# M\_(TT)CAN

Functional Changes

R3.0.1 to R3.1.0

05.06.2014

Figure 2: Tx Buffer Element

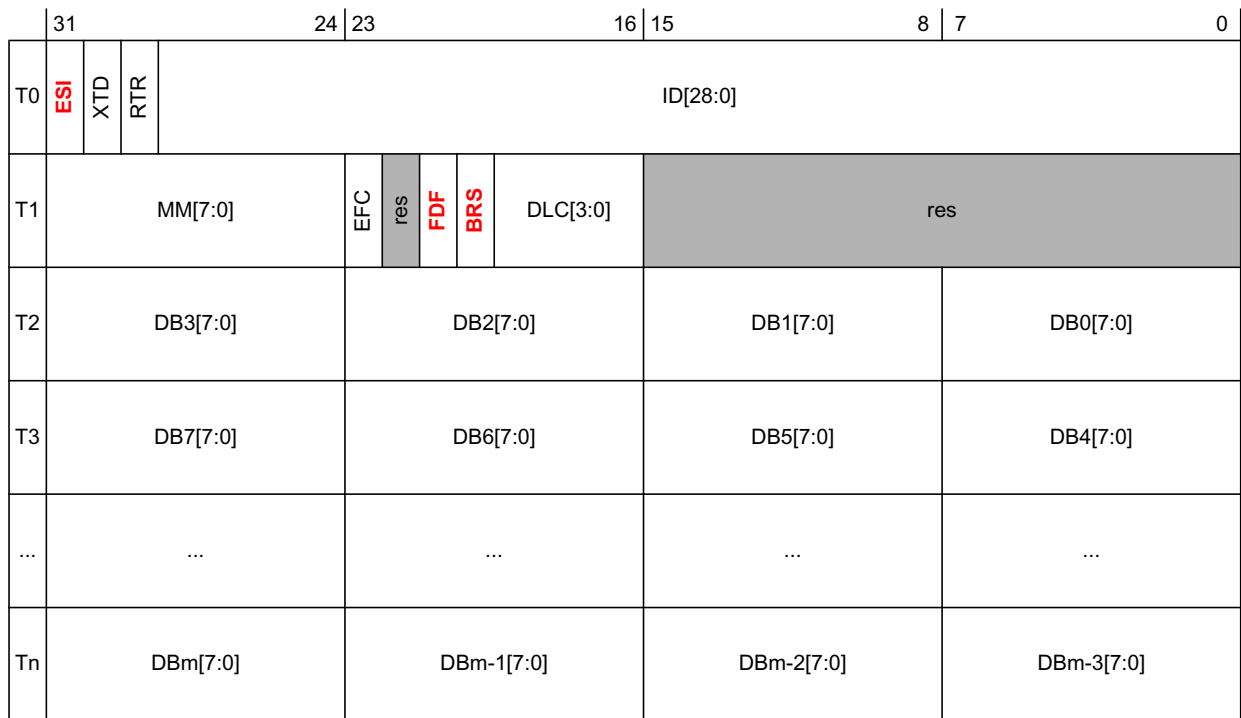
R3.0.1 software has to be updated with respect to handling of transmit messages. The configuration of Tx Buffer elements and enabling of CAN operation modes has been changed for M\_CAN / M\_TTCAN R3.1.

Configuration bit **ESI** added. The **ESI** bit of the Tx Buffer element is or'ed with the error passive flag to decide the value of the **ESI** bit in the transmitted frame. As required by the CAN FD protocol specification, an error active node may optionally transmit the **ESI** bit recessive, but an error passive node will always transmit the **ESI** bit recessive. This feature can be used in gateway applications when a message from an error passive node is routed to another CAN network.

Configuration bits **FDF** and **BRS** added. Now the transmit mode can be configured individually for each Tx Buffer element. Bit **FDF** of a Tx Buffer element decides whether the frame is transmitted in FD format. In addition bit **BSR** configures transmission with bit rate switching.

Figure 3: CC Control Register

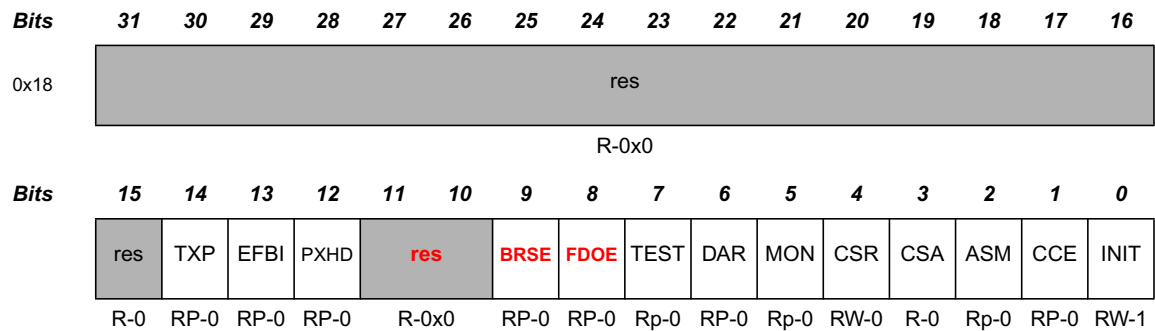
The Tx Buffer element bits **FDF** and **BRS** replace the global CAN operation mode control **CCCR.CMR** of R3.0.1.

Transmission of FD frames has to be enabled by configuration bits **CCCR.FDOE** and **CCCR.BRSE**. Figure 4 lists the possible configurations for frame transmission.
